**PRODUCTION CHANGE  
and  
SERVICE BULLETIN**

"NEW"  
KNOB AND LEAD-SCREW  
'FOR CARBON PILE'

MARCH 1981

"NEW" CARBON PILE KNOB ASSEMBLY AND LEAD-SCREW  
#7009-1457 #0784-0001

K N O B  
#7009-1457

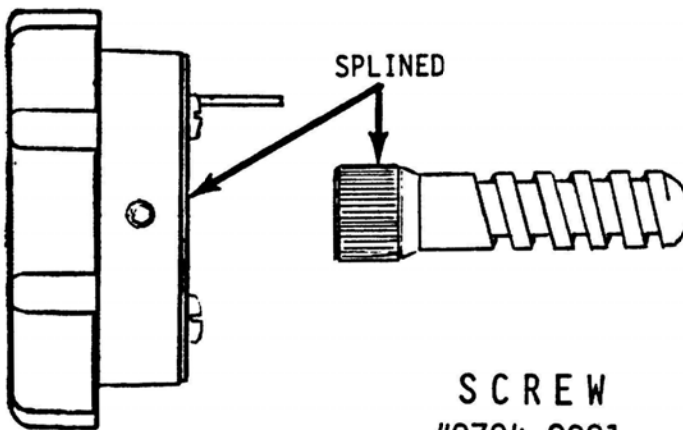
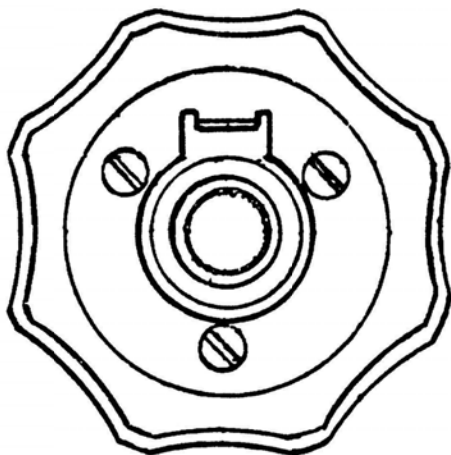
DUE TO FIELD REPORTS REGARDING SLIPPAGE BETWEEN THE CARBON PILE'S LEAD SCREW AND CONTROL KNOB, A "NEW" SPLINED LEAD SCREW (#0784-0001) AND A MATCHING SPLINED CONTROL KNOB (#7009-1457) HAVE BEEN RELEASED FOR ALL SERVICE AND "NEW" PRODUCTION VAT-40 TESTERS.

NOTE: THE "NEW" KNOB AND THE "NEW" LEAD-SCREW MUST BE USED AS A SET WHEN SERVICING TESTERS MANUFACTURED PRIOR TO 2ND QUARTER 1980 PRODUCTION (DATE CODE "20").

ALL VAT-40 TESTERS DATE CODED "20" OR LATER WILL INCORPORATE THIS CHANGE.
